POWER PLANT - ENGINE - INCORPORATE REVISED BRACKET ATTACHING BOLTS AT THE FLANGE FA1 -  
CATEGORY CODE 3 - MOD.ENG-71-0057

V2500-ENG-71-0057

Location of the flange holes at the flange FA1  
Fig.1

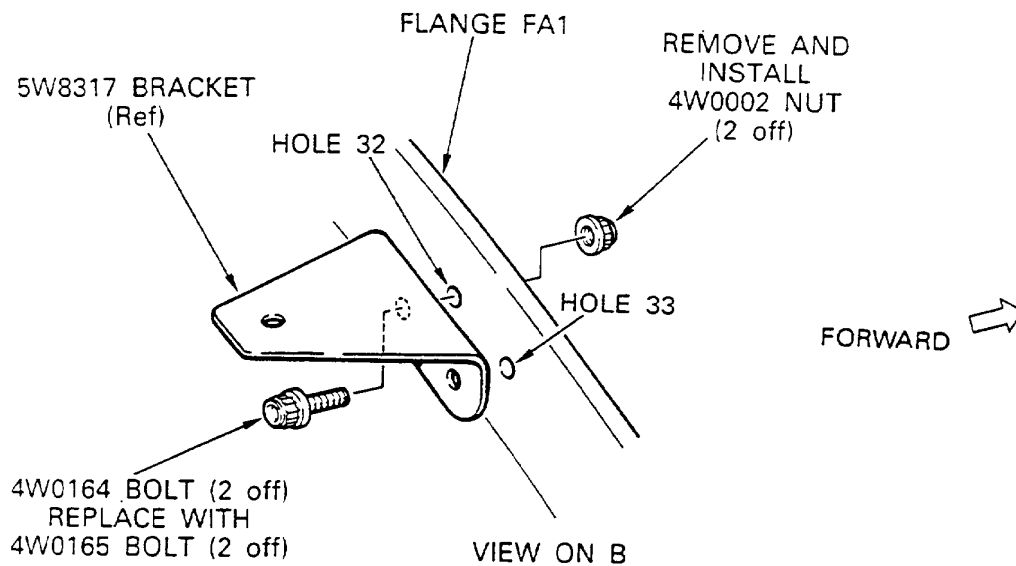
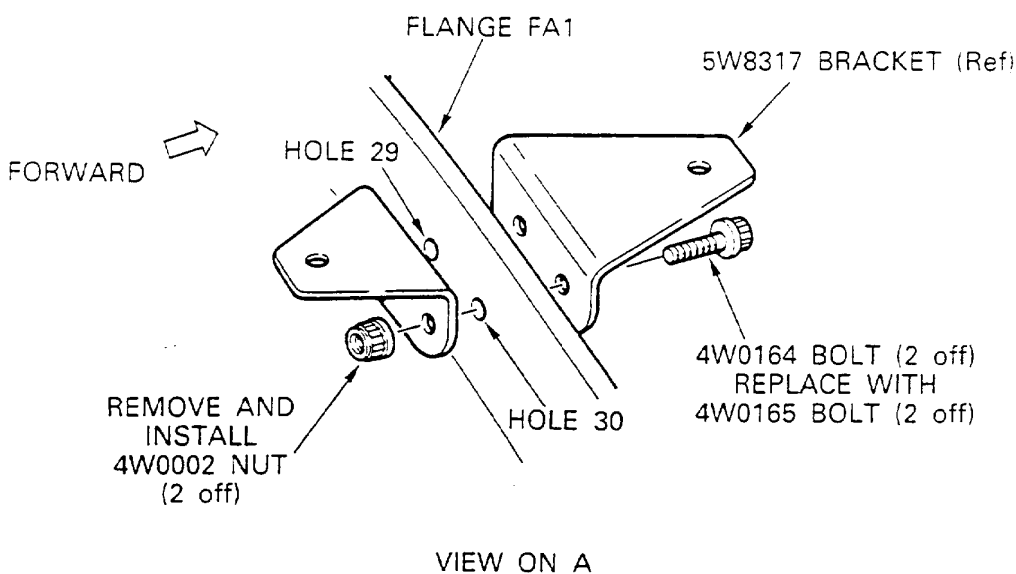
- (1) Find the flange holes 29, 30, 32, 33, 57, 63, 64, 67 and 68 on the flange FA1 where the brackets including bracket PN 5W8317 are installed (Refer to Figures 1 and 2.)
- (2) At each flange hole 29, 30, 32, 33, 57, 63, 64, 67 and 68, remove PN 4W0002, nut, and PN 4W0164, bolt from the flange FA1 and the brackets. (Refer to Figures 1 and 2.)
- (3) At each flange hole 29, 30, 32, 33, 57, 63, 67 and 68, install PN 4W0165, bolt, and PN 4W0002, nut to the brackets and the flange FA1. (Refer to Figures 1 and 2.)
- (4) At each flange hole 29, 30, 32, 33, 57, 63, 64, 67 and 68, tighten PN 4W0002, nut on PN 4W0165, bolt with a torque of 85-95 lbfin (9,6 - 10,7 Nm). (Refer to Figures 1 and 2, and the Aircraft Maintenance manual, 70-23-11, Torque Tightening Technique).

Replacement of the bracket attaching bolts on flange FA1  
Fig.2

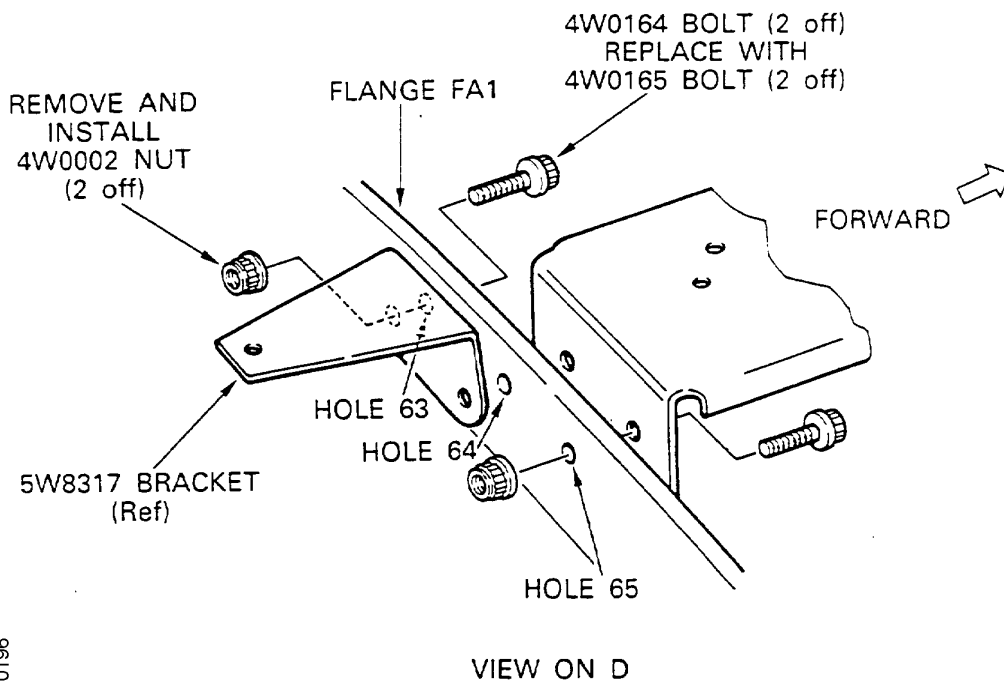
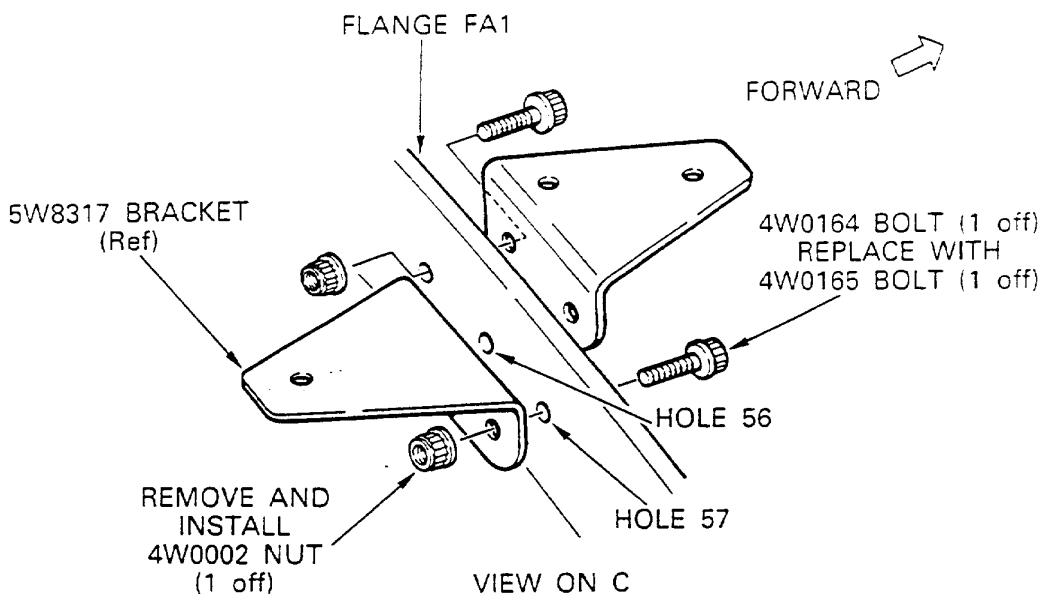
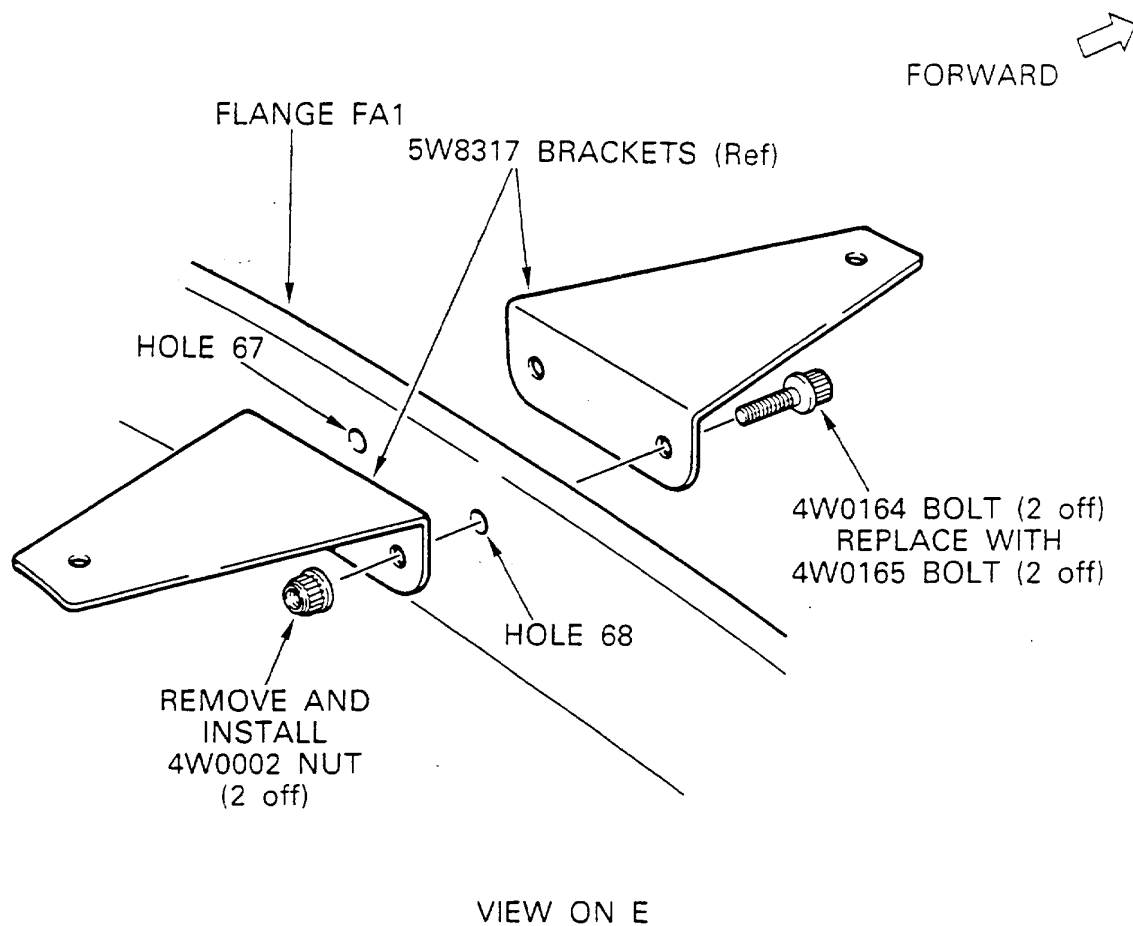
(a) The existing bolts which install the brackets including the bracket PN 5W8317 to the flange FA1, have been changed from PN 4W0164 to PN 4W0165 to increase the bolt length.
